**REZONING,
PLANNED UNIT DEVELOPMENT &
SUBDIVISION STAFF REPORT**

<u>DEVELOPMENT NAME</u>	University Club Apartments
<u>SUBDIVISION NAME</u>	University Club Apartments
<u>LOCATION</u>	139 East Drive (East side of East Drive, 900'± South of Old Shell Road, extending to the West side of Long Street, 600'± South of Old Shell Road)
<u>CITY COUNCIL DISTRICT</u>	District 6
<u>PRESENT ZONING</u>	R-3, Multi-Family Residential
<u>PROPOSED ZONING</u>	R-3, Multi-Family Residential
<u>PRESENT ZONING</u>	R-3, Multi-Family Residential
<u>AREA OF PROPERTY</u>	1 lot / 8± Acres
<u>CONTEMPLATED USE</u>	To remove zoning condition(s) and to construct multiple buildings on a single-building site.
<u>TIME SCHEDULE FOR DEVELOPMENT</u>	Immediate
<u>ENGINEERING COMMENTS</u>	Engineering will require a 100' drainage easement along existing storm ditch (12 mile creek). And due to existing flooding problems in the area, Engineering will require storm water detention for a 100 year flood. In addition, if access to Long Street is required/approved Engineering will require it be improved to city standard. Must comply with all stormwater and flood control ordinances. Any work performed in the right of way will re

SITE PLAN

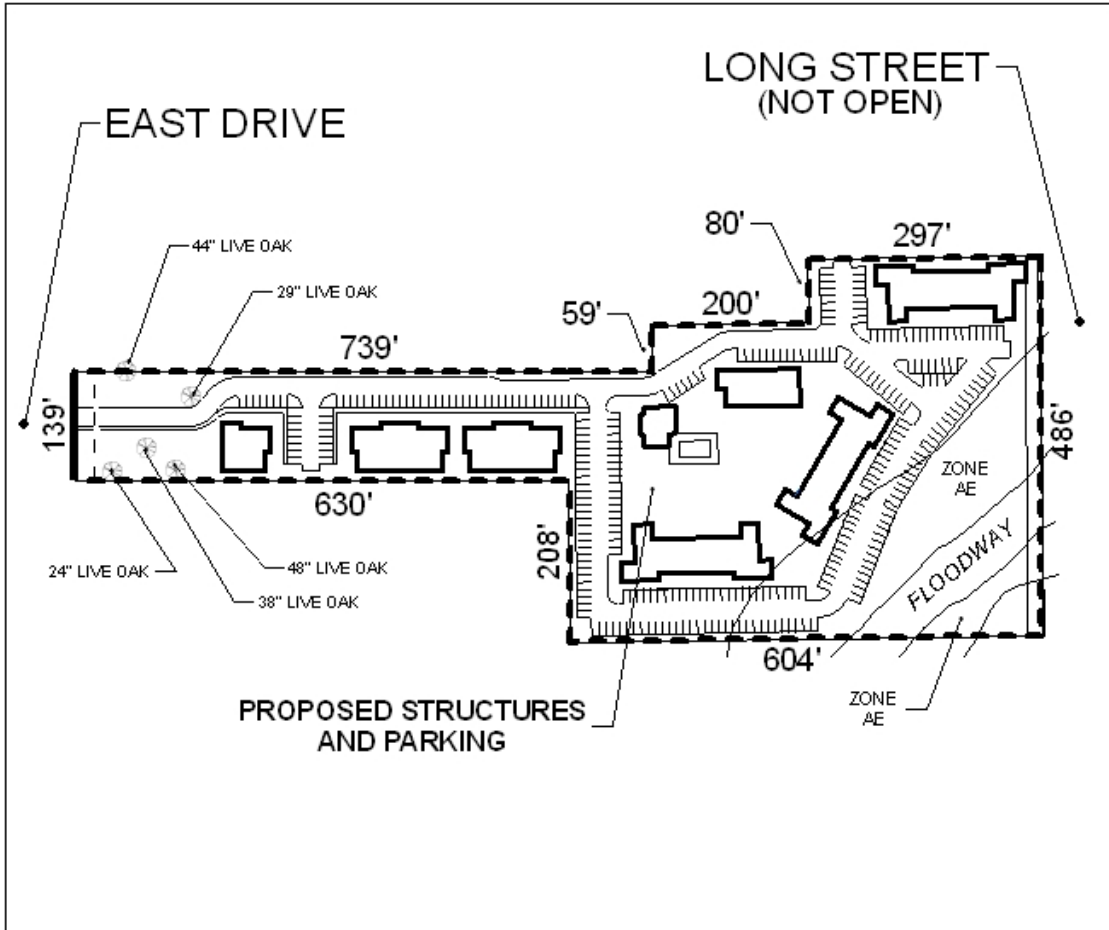
There are two other zoning conditions that are not reflected on the current site plan. First, the property adjoining the site to the south (along Long Street) actually exists as two separate parcels which are separated by the creek bed, thus the western parcel is land-locked. Condition 1 above, required the provision of a 50 foot easement to the land-locked property to the South. As the site is still land-locked the easement should still be provided, and no parking should be allowed to block the easement.

In regard to access, the site plan does not illustrate access to Long Street, nor is construction of Long Street proposed. The site plan illustrates the construction of 144 units, with 302 parking spaces, and the only access is to East Drive. Typically for this number of units, the Commission requires at least two points of access. Furthermore, an application for a 14 lot, single-family residential subdivision (compliance with R-3 conditions were not required) was approved by the Commission in 2003, and the Commission required construction of Long Street to a standard approved by City Engineering. The prior application proposed a wing gutter street design for Long Street. The construction of Long Street to a standard approved by City Engineering should be required. Additionally, with the construction of Long Street, the site plan should be modified to allow an additional point of access to Long Street

Regarding parking, the site will consist of 144 units, and 302 spaces are provided, which exceeds the required number of spaces (216). It should be noted that if the buildings are two stories in height, the PUD section of the Ordinance establishes minimum distance requirements between buildings; therefore, the spacing of the buildings must comply with Section V.C.2.b. of the Ordinance.

Planned Unit Development Based upon the preceding, this application is recommended for approval subject to the following conditions: 1) the provision of a 50' easement to the land-locked property to the South; 2) construction of Long Street to a standard approved by City Engineering; 3) full compliance with the landscaping and tree planting requirements of the Ordinance; 4) the provision of a sidewalk along the improved portion of Long Street, and the construction of a driveway to Long Street; 5) the provision of a six foot wooden privacy fence, as well as a 10' buffer where the site adjoins R-1 zoning; 6) full compliance with all City Engineering Comments (provision of a 100' drainage easement along existing storm ditch [12 Mile Creek], provision of storm water detention for a 100 year flood, any work performed in the right of way will require a right of way permit); 7) full compliance with Traffic Engineering Comments (driveway number, size, location, and design to be approved by Traffic Engineering and conform to AASHTO standards, and widening of parking aisles to 24-feet for two-way traffic flow); 8) the approval of all applicable federal, state and local agencies; 9) compliance with Section V.C.2.b. regarding building spacing; and 10) full compliance with all municipal codes and ordinances.
